SUPPLEMENTAL HYDROLOGIC ENGINEERING SUMMARY
ON STALLED HURRICANES
ST. LUCIE UNITS 1 & 2
DOCKET NUMBERS: 50-335 & 389

Subject: Review of Hurricane stalls and loops pertinent
to the St. Lucie site, Florida. Re: Order No. DR-75-0886

CHARACTERISTICS OF STALLED OR LOOPING HURRICANES

FIGURE 1

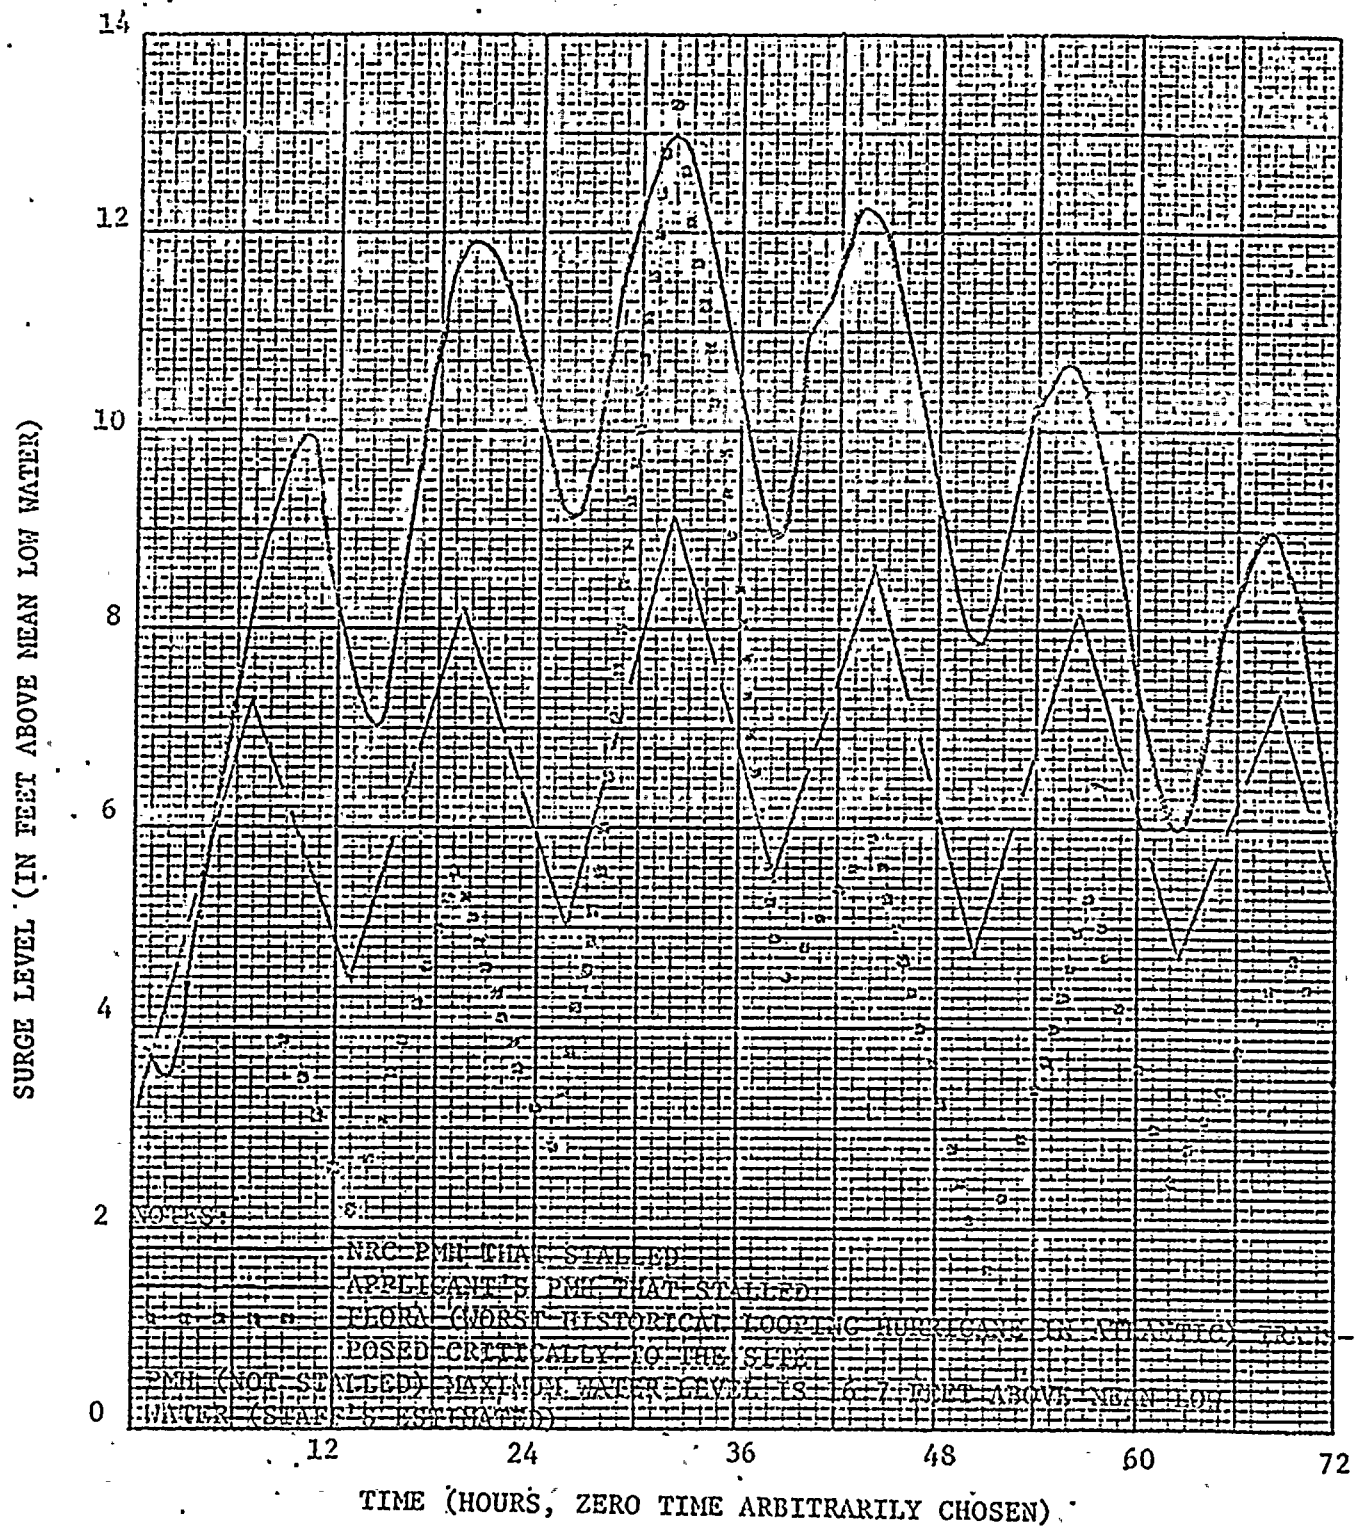
the event we postulated. We reviewed the applicant's analyses, and independently evaluated the surge and wave conditions for our postulated PMH that stalled. Figure 1 presents estimates of surge levels as a function of time above +8 feet mean low water (MLW) (independent of waves) for (1) our postulated PMH that stalled; (2) the applicant's postulated PMH that stalled; and (3) Flora, the worst historical looping hurricane in the Atlantic identified by the applicant, transposed critically to the site. These surge estimates were made using the same predictive models associated with the PMH discussion in the SER.
